Town of Hilton Head Island
Design Review Board Meeting
Tuesday, August 10, 2021 – 1:15 p.m.
Benjamin M. Racusin Council Chambers

AGENDA

i. The Charles, DRB-001776-2021

DESIGN TEAM/DRB COMMENT SHEET

THE CHARLES
EXTERIOR ELEVATIONS

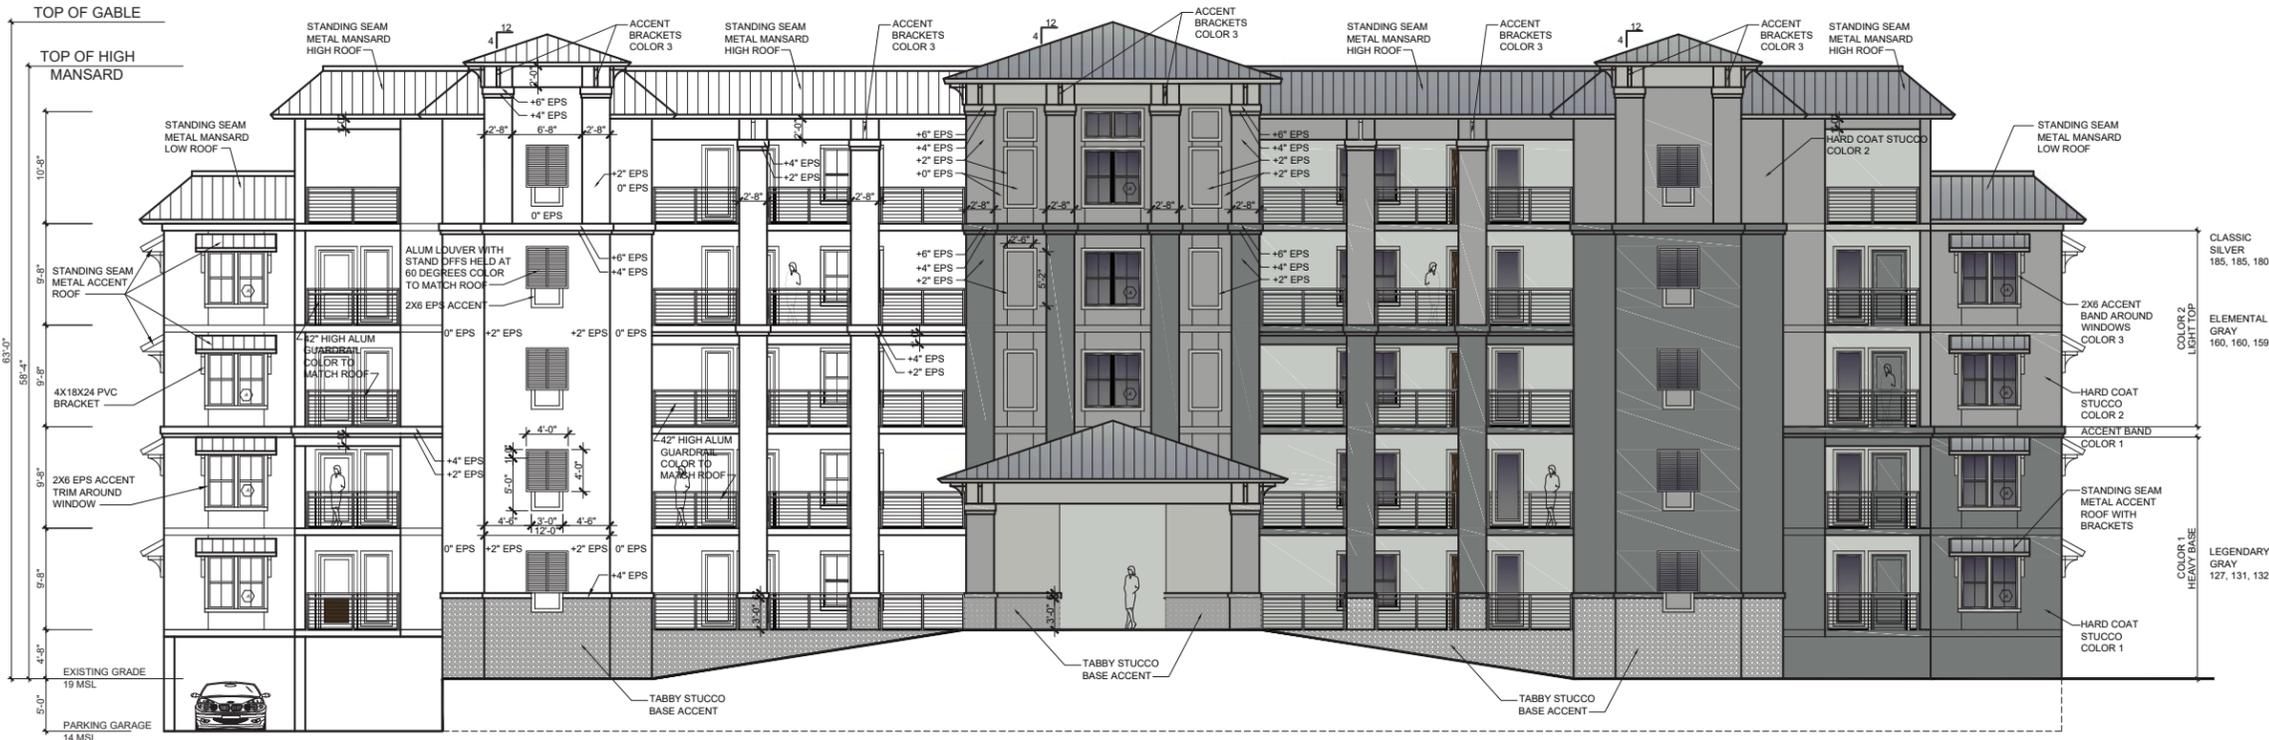
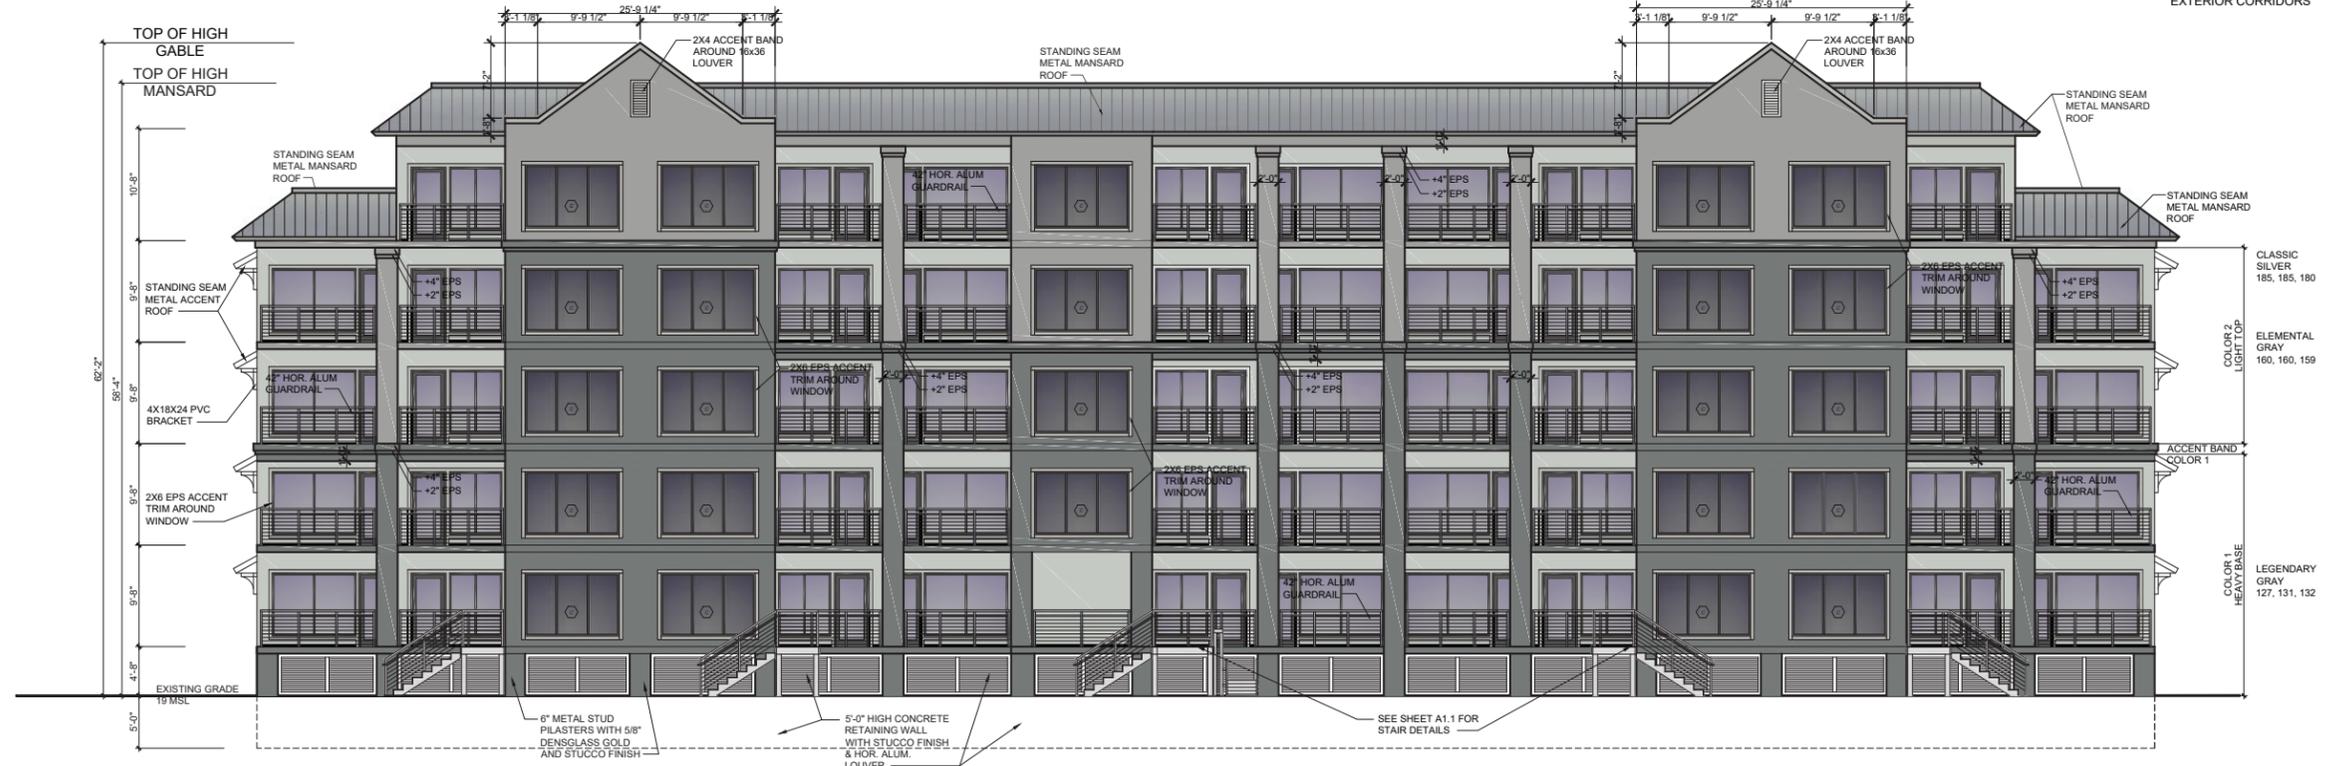
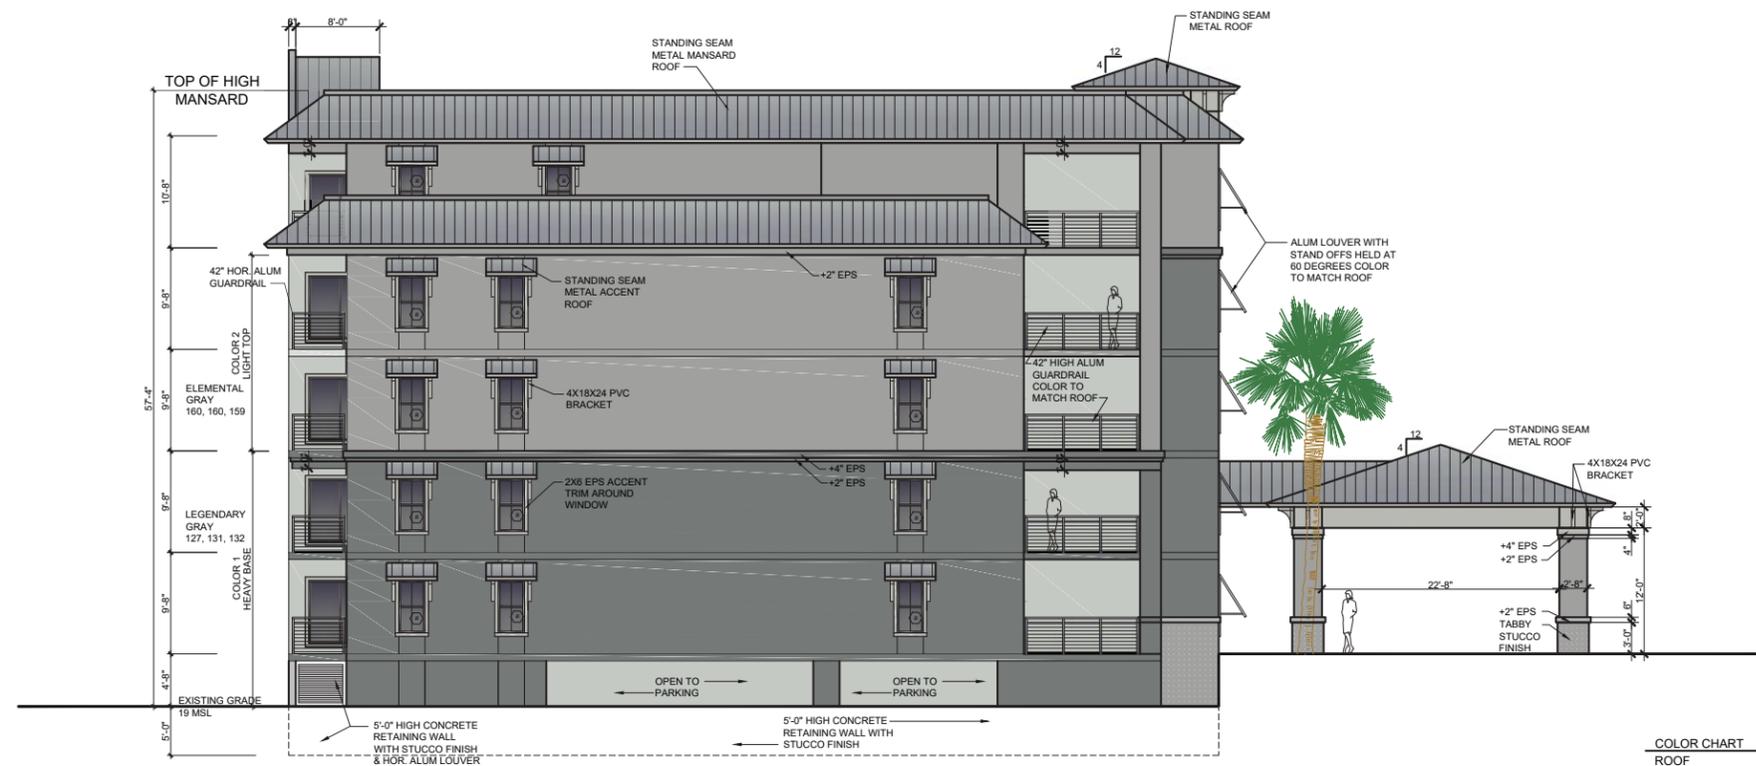
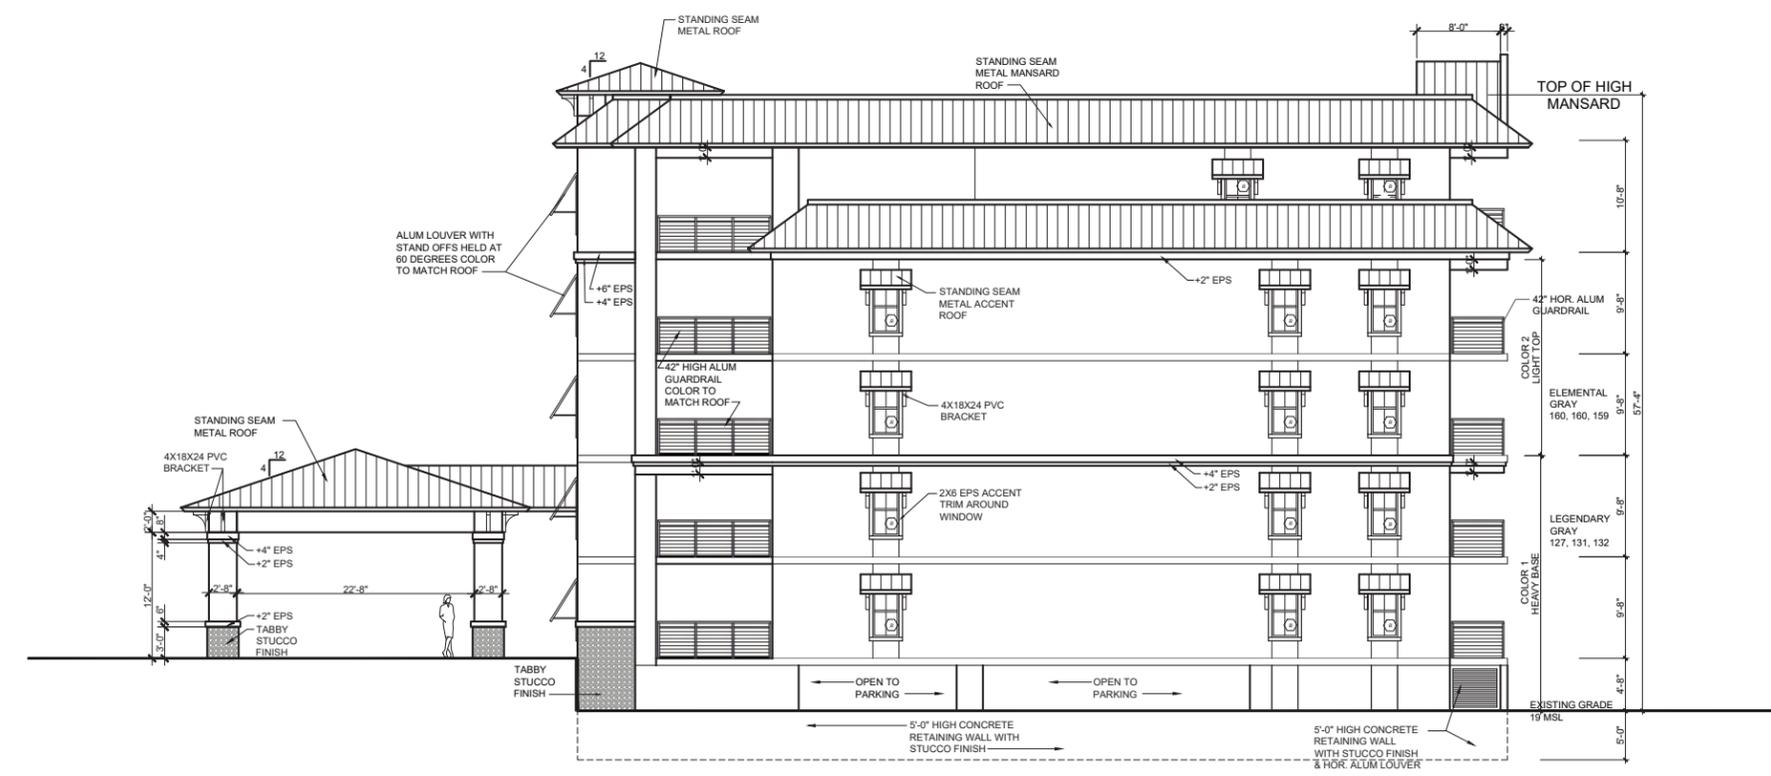
1. Dimension the 5' roof height of A2.1 and A2.2.
2. Provide a landscape plan of a scope, size and design in proportion to the scale of the development.
